PROJECT: DA084

ACCESSORY BUILDING - DETACHED CARPORT

3507 14A STREET SW,
CALGARY AB T2T 3Y1

DEVELOPMENT PERMIT PACKAGE

SHEET TITLE:
ELEVATIONS AND
GENERAL NOTES

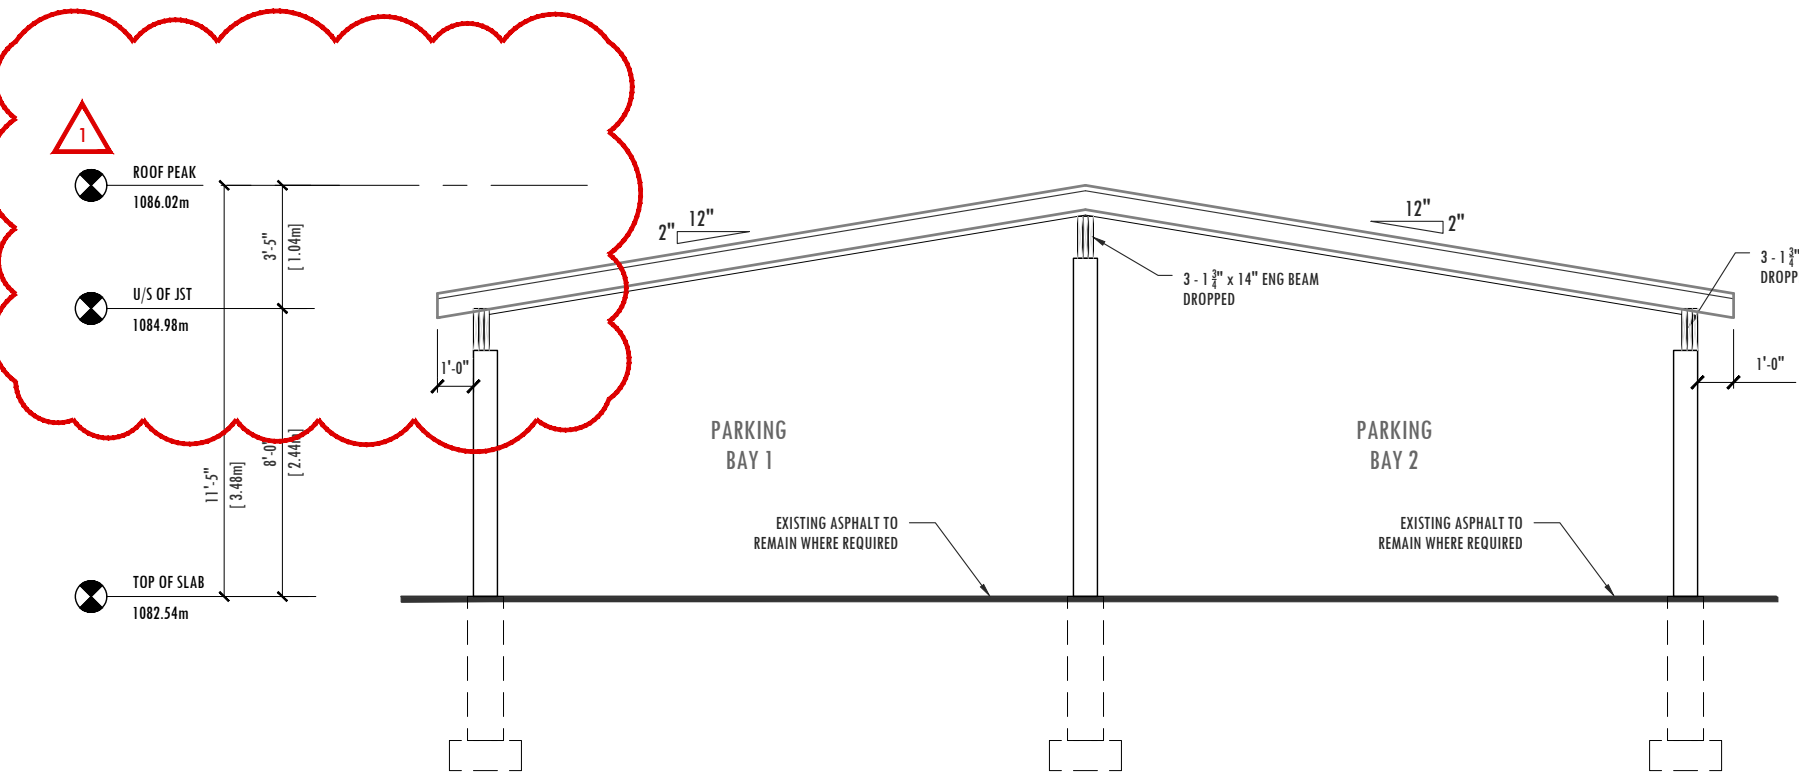
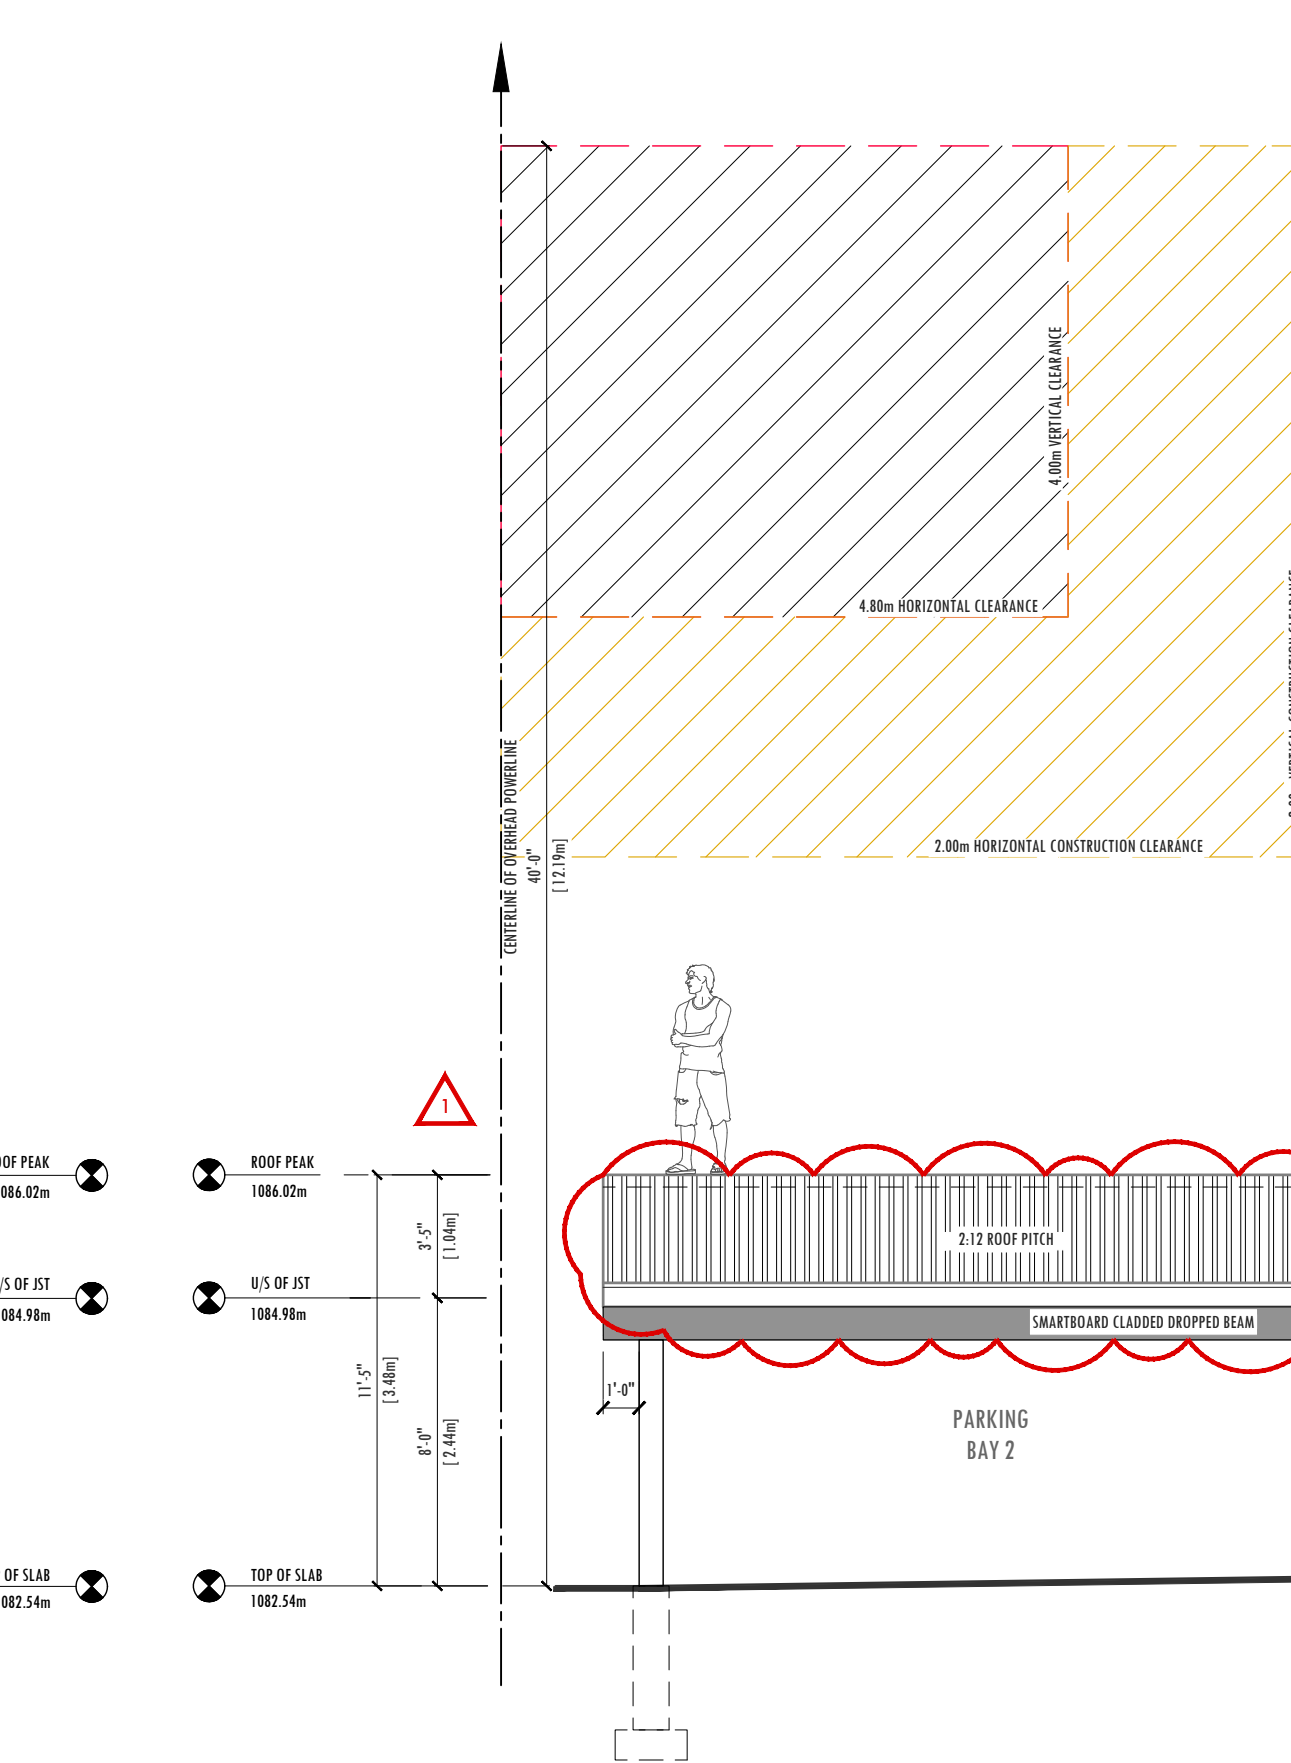
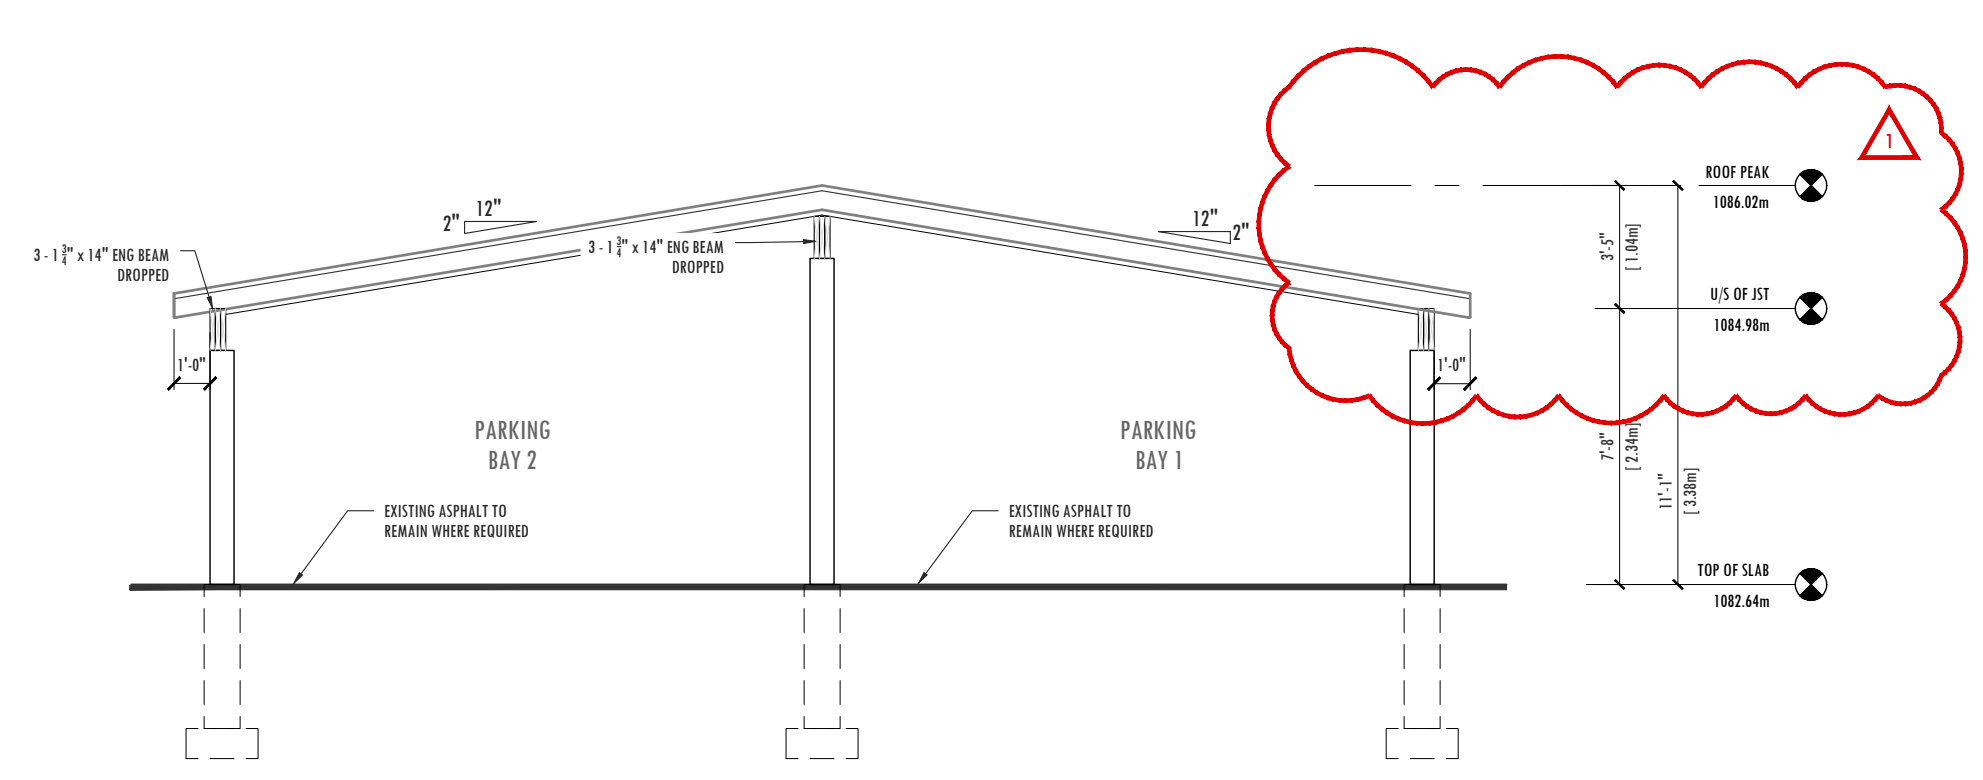
▲ 1 - Due to ENMAX's clearance from the secondary overhead powerline, the carport overall building height is reduced by 6". In addition the roof framing has been altered from attic ceiling to cathedral. See elevations and cross sections for clarification.
